Addendum No. 2
February 2, 2026

Project: Sioux Falls Washington and Roosevelt High School Auditorium Renovations
Sioux Falls, South Dakota
Project #3021

Architect: Architecture Incorporated

R4.20

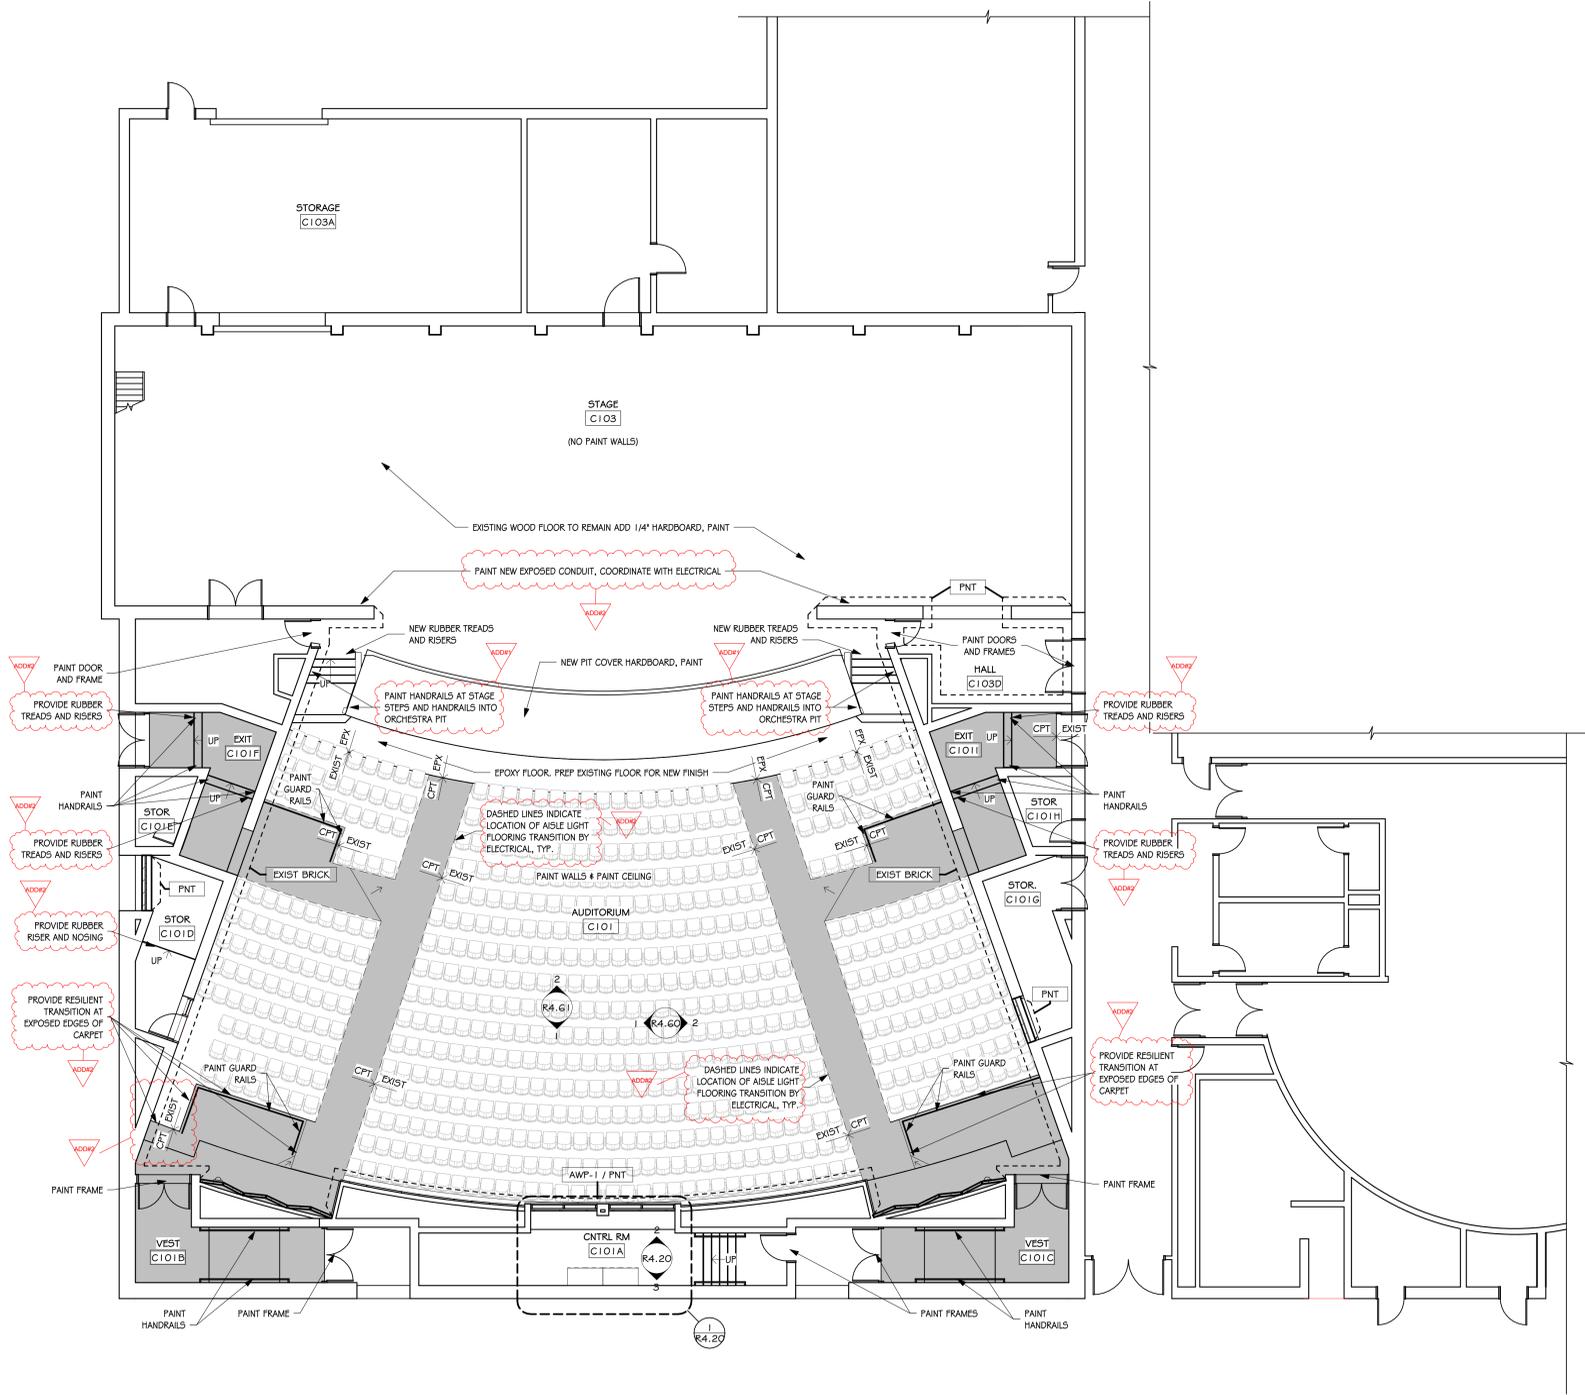
- 7) SHEET R4.20 – FINISH PLAN – LEVEL 1
- a) Paint new electrical conduits on south wall of stage as shown on drawing. Coordinate locations with electrical.

- b) Revise location of carpet transition at southwest corner of Auditorium.
 - c) CLARIFICATION: Refer to revised drawing sheet R4.20 for clarification of flooring transition types and locations. Coordinate with electrical drawings.

- d) CLARIFICATION: Refer to revised drawing sheet R4.20 for clarification of rubber nosings and tread and riser locations.
 - e) Reference revised drawing Sheet R4.20, revision dated 2-2-26, attached to the end of this addendum.

R4.21

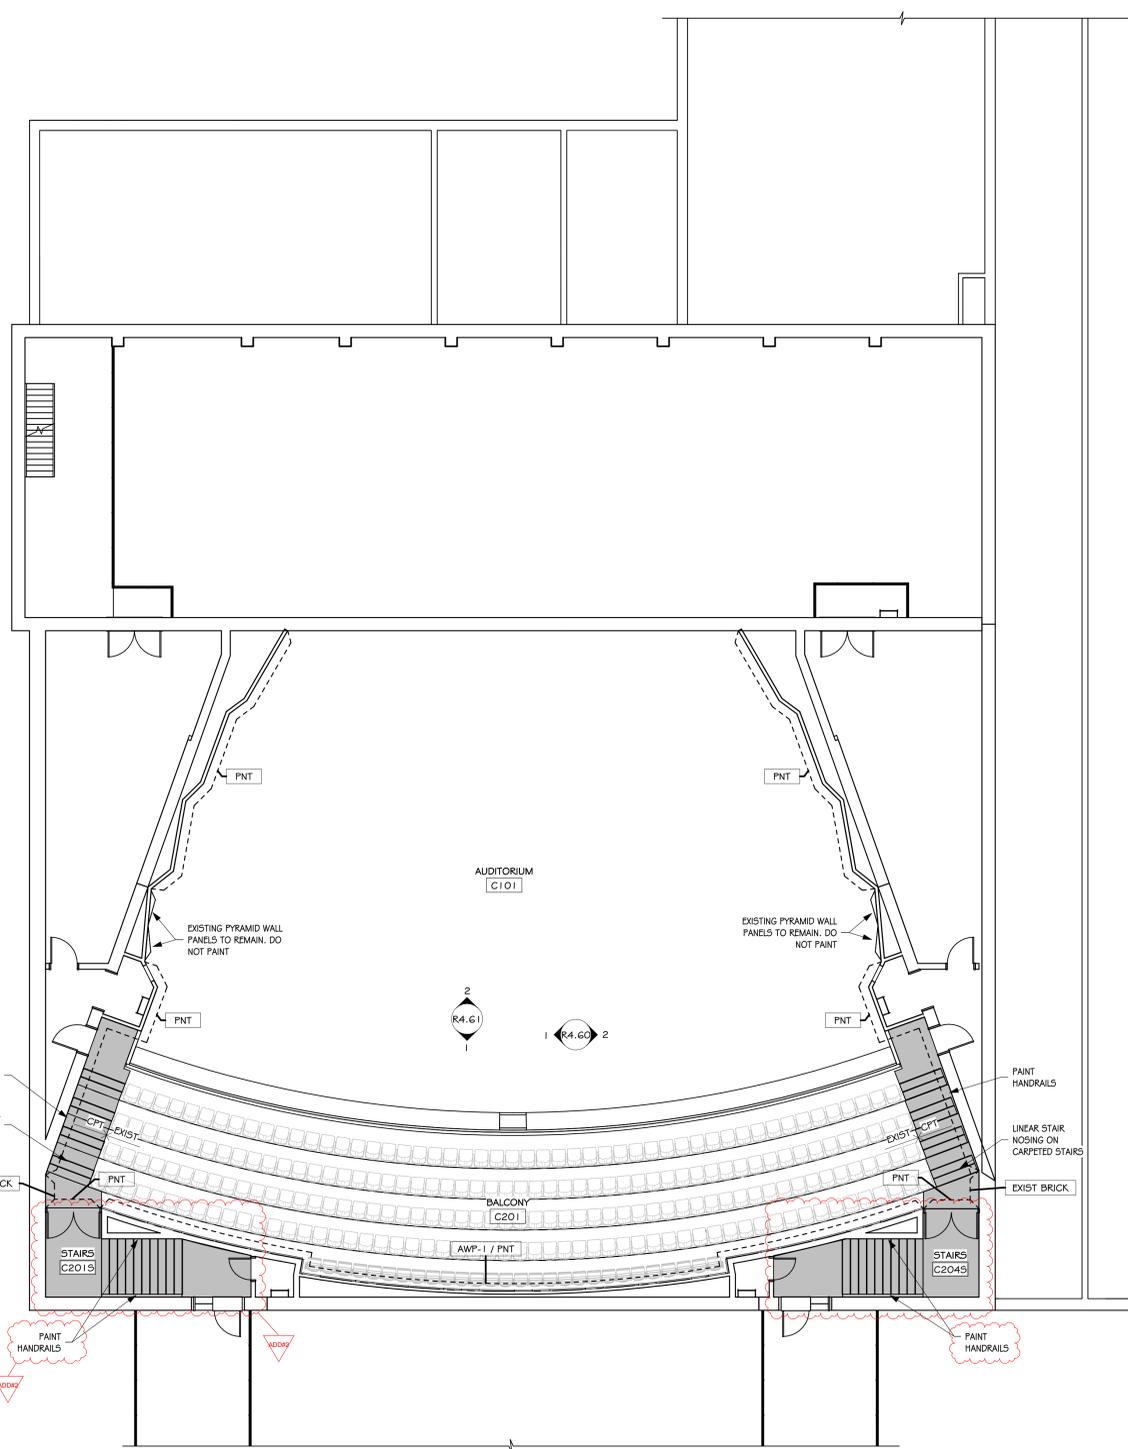
- 9) SHEET R4.21 – FINISH PLAN – BALCONY
- a) Omit reference to painting metal guardrail at balcony. Aluminum rail to remain no finish.
 - b) Reference revised drawing Sheet R4.20, revision dated 2-2-26, attached to the end of this addendum for room finishes added for C210S Stairs and C204S Stairs and painting handrails at stairs.

R5.41

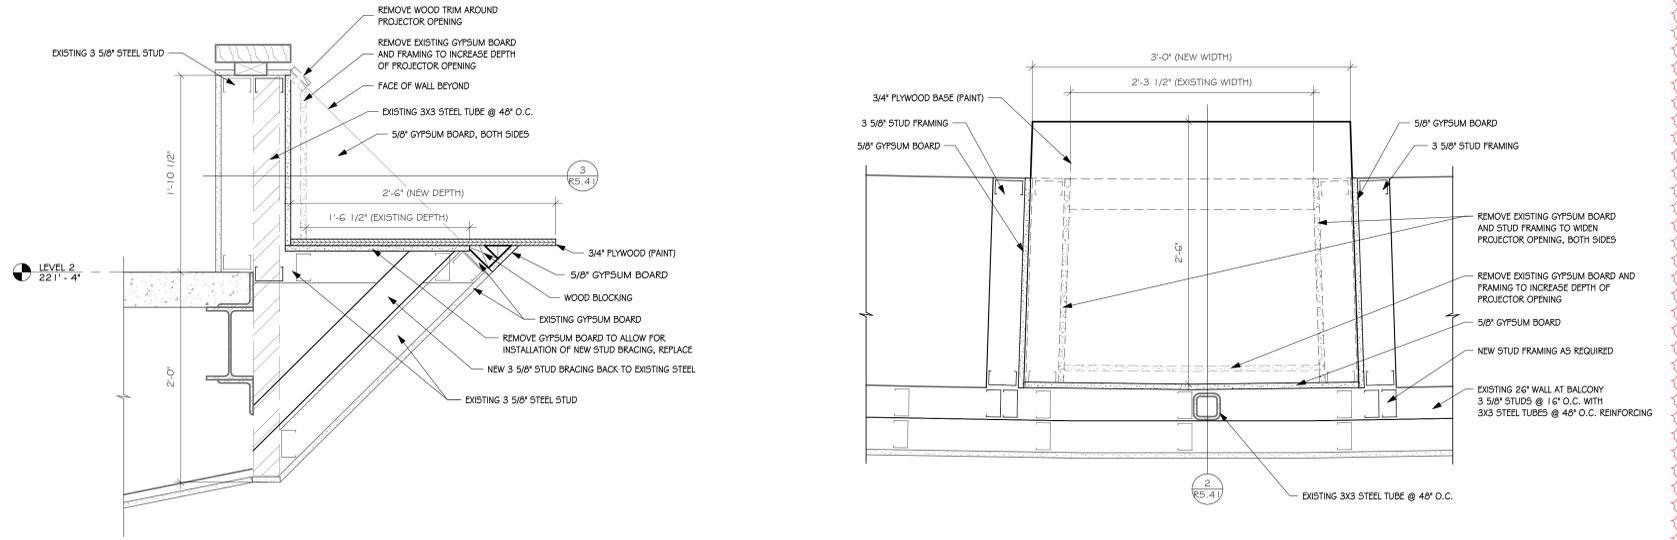
- b) Reference revised drawing Sheet W5.41, revision dated 2-2-26, attached to the end of this addendum.
- 13) SHEET R5.41 – DETAILS
- a) See details 2/5.41 and 3/5.41 for revisions to gypsum board balcony framing for installation of video projector. Existing space width will be wider. Section detail 2/R5.41 in reference to section 1/R5.20. Plan detail 3/R5.41 in reference to plan view of projector opening on R4.11.

- b) Reference revised drawing Sheet R5.41, revision dated 2-2-26, attached to the end of this addendum.

REFLECTED CEILING PLAN - FIRST FLOOR
SCALE: 1/8" = 1'-0"

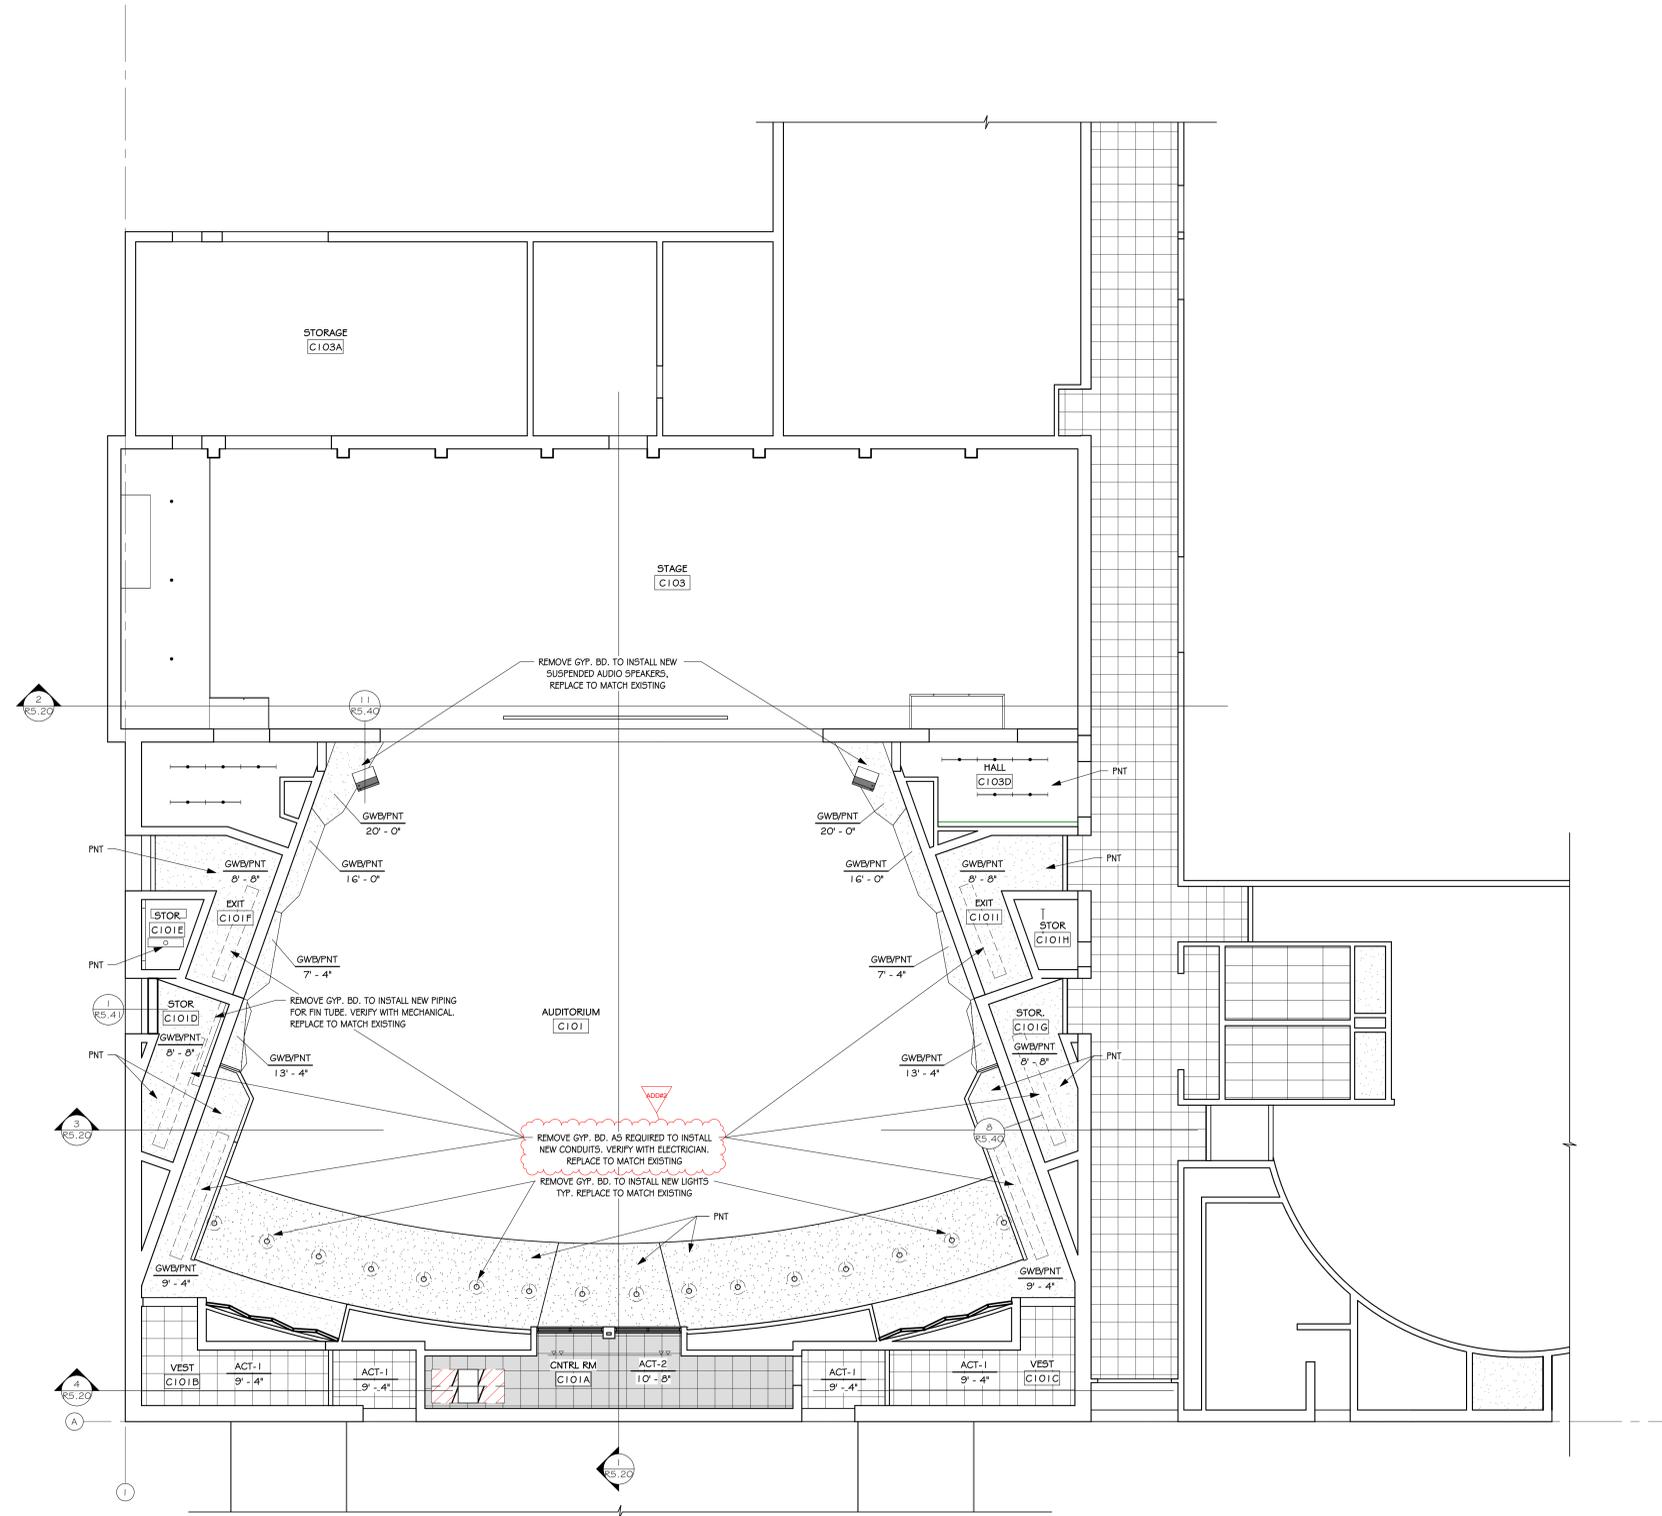
- 15) SHEET R6.10 – REFLECTED CEILING FIRST FLOOR
- a) Reference revised drawing Sheet R6.10, revision dated 2-2-26, attached to the end of this addendum for additional gypsum board ceilings to be removed and replaced to allow installation of new electrical conduit. Coordinate locations with electrical.

R8.30

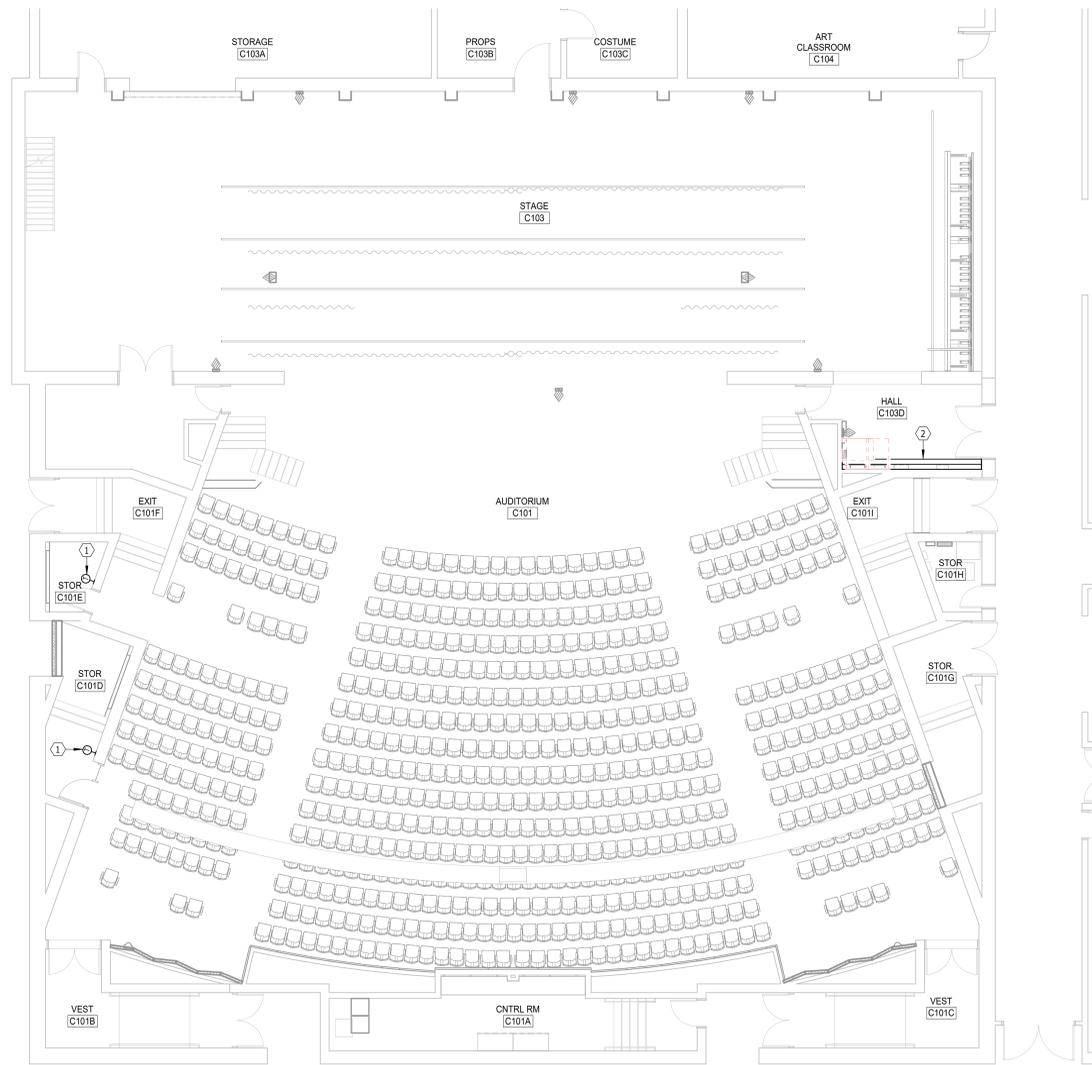
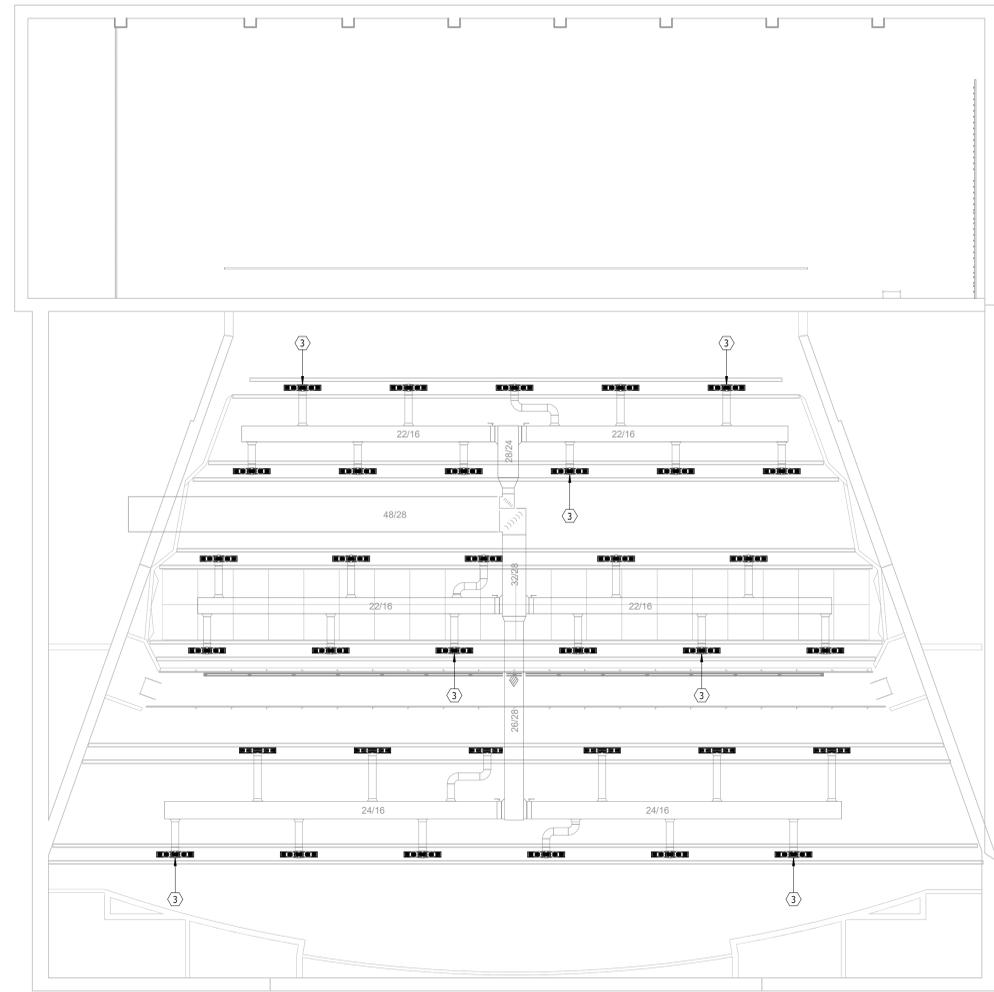
- 1) SHEET W8.30 – UPPER FLOOR PLAN VENTILATION
- a) Reference ventilation note 3: General Contractor has option to remove the existing slot diffusers at the ceiling either by a mechanical contractor or by the general contractor. Remove diffuser, clean plenum and prep for paint.
- b) Update Ventilation Note No. 2 to include “TYPICAL OF 34.” as shown on revised plan sheet dated 2-2-2026.
- c) First Floor Plan – Omit “V” shaped drip pan for existing roof drain.
- 2) SHEET R8.30 – UPPER FLOOR PLAN VENTILATION

- a) Reference ventilation note 3: General Contractor has option to remove the existing slot diffusers at the ceiling either by a mechanical contractor or by the general contractor. Remove diffuser, clean plenum and prep for paint.
- b) Update Ventilation Note No. 3 to include “TYPICAL OF 34.” as shown on revised plan sheet dated 2-2-2026.
